**Planning Permit PA2000891 – 77-83 Sutton Street, North Melbourne – Section 72 Amendment and Submission of Plans and Reports for Endorsement (Conditions 1, 7, 9, 15, 18, 22, 27, 28, 31, 35, 37, 57 and 58)**

Following on from correspondence with the Department of Transport and Planning (DTP) and the City of Melbourne ('Council') this request seeks to amend the Permit to facilitate revised rear setback and basement arrangements that will both provide an improved public realm outcome and are critical to the development's constructability. The proposed amendments also provide a public realm and laneway arrangement that is consistent with the Macaulay Structure Plan 2021.

Figure 2 - Excerpt of Amended Basement Level 1 Plan (Point Architects)

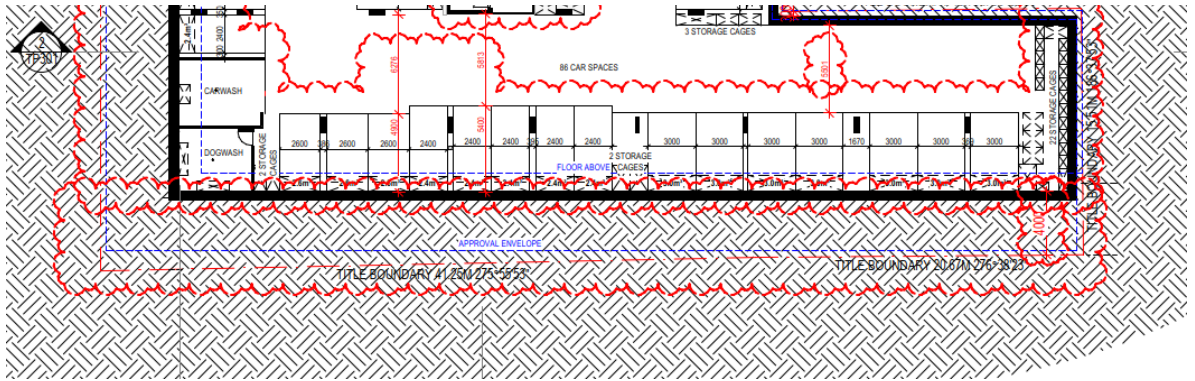
Following the issuing of the Permit the project team has been involved in further detailed design of the development. In order to lift the building out of the water table Point Architects have sought to reduce the floor-to-floor heights within the basement levels.

In doing so it has become impossible to accommodate the 1500mm clearance under the southern laneway that the Council has required under various conditions of the Permit without losing a large number of car parking spaces and imposing substantial costs on the applicant as a result of a considerably more complicated construction programme.

Based on the revised basement arrangement, this area would be able to accommodate a 3.4m wide area of deep soil (with a total area of approximately 240sqm) to accommodate future deep soil planting or WSUD treatments, while offering a gathering space and improved pedestrian experience for users of the future laneway.

Figure 3 - Excerpt of Amended Ground Floor Plan (Point Architects)

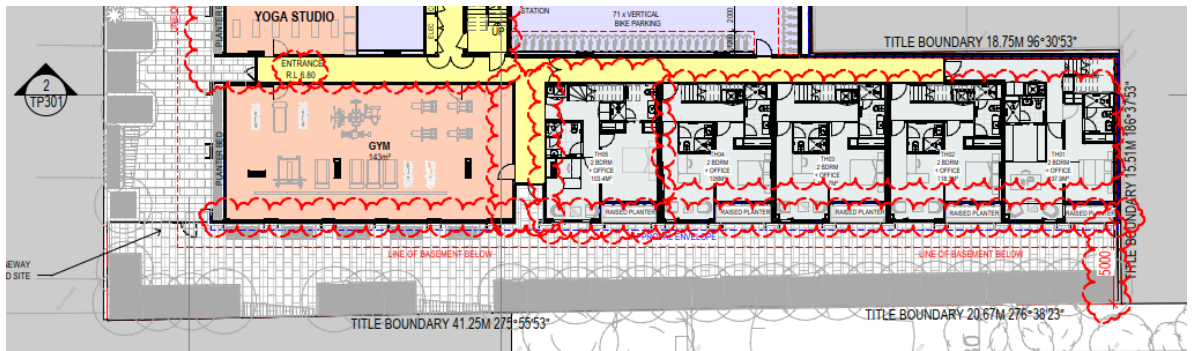
Moreover, as noted in Section 2.1 above the delivery of a public laneway in this location is no longer consistent with Council's preferred location of new streets and laneways within the Precinct. On this basis it is submitted that delivering this area as a publicly accessible and privately owned plaza – similar in nature to the north-south aligned laneway along the Site's western boundary - will be a more appropriate outcome for this portion of the Site and will continue to provide a demonstrable public benefit in accordance with the DDO63.

- Revised RL heights to Basement Level 1 and Ground Level to shift basement out of the water table resulting in the ground floor being lifted from R.L 6.10 to R.L 6.80. Levels 1 and above have been raised by 300mm.

Figure 4 - Excerpt of Amended North-South Section (Point Architects)

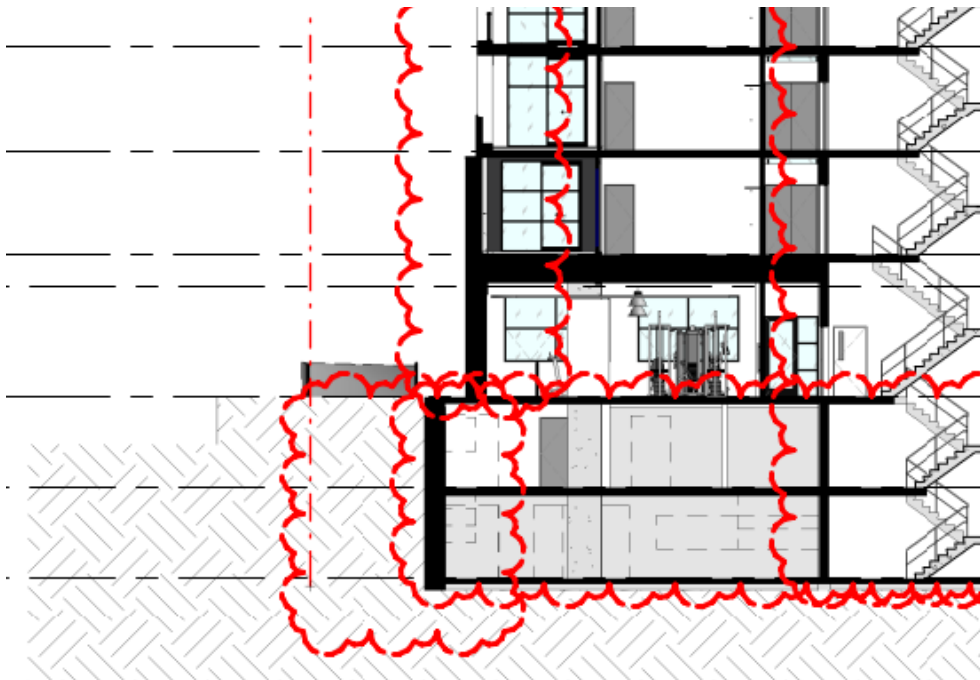
These variations will ensure a more consistent arrangement in terms of the ownership and management of publicly accessible space within the Macaulay Precinct. Given it is now proposed for the applicant to have ongoing ownership of the land, it is no longer necessary for the southern setback of the Site to be unencumbered by basement.
